Your Ref: SSD 7919
Council Ref: DA371/17
(KRR) (CIS)

RE: REDEVELOPMENT OF LORETO SCHOOL (MASTERPLAN, STAGE 1 AND CONCEPT STAGE 2 AND 3)

North Sydney Council appreciates the opportunity to provide further comment on the concept proposal and Stage 1 development for the Loreto School campus.

Figure 1 – Extract from Height of Building Map in NSLEP 2013

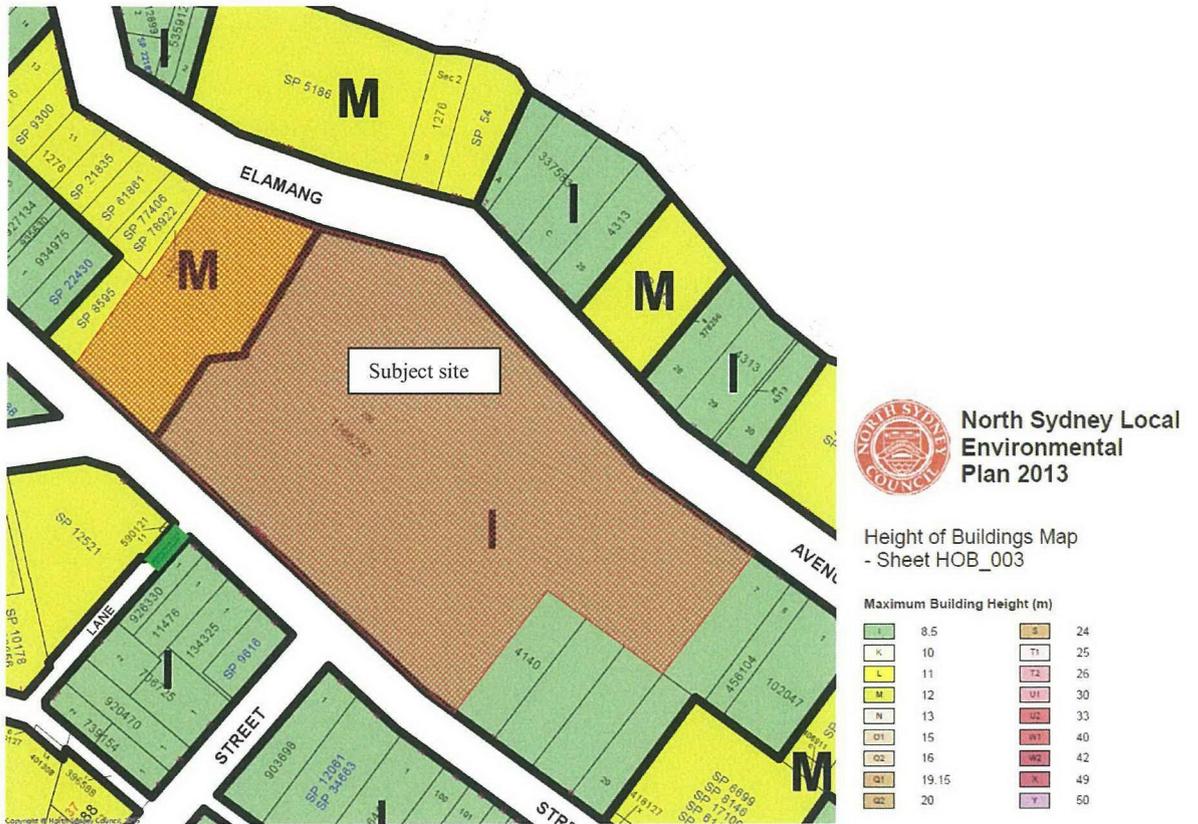
Clause 4.3(3) of NSLEP 2013 states that the maximum permitted building height on the site is 12 meters over the portion of the site which is zoned R4 High Density Residential. The works of most significance in the Stage 1 Western Precinct include the 7 story learning hub and an overall height of 14.5 metres exceeding the height limits for this zoning (12 metres).

North Sydney Council is of the view that the scale of the New Buildings particularly the new additions to the western building (Learning hub) located close to the adjoining boundary site are incompatible with the sites adjoining and opposite along Carabella Street and Elamang Avenue. Existing buildings at the eastern end of the sites are zoned R2 Low Density Residential with a maximum permissible building heights of 8.5 m (**refer to Figures 1 and 2 below**).
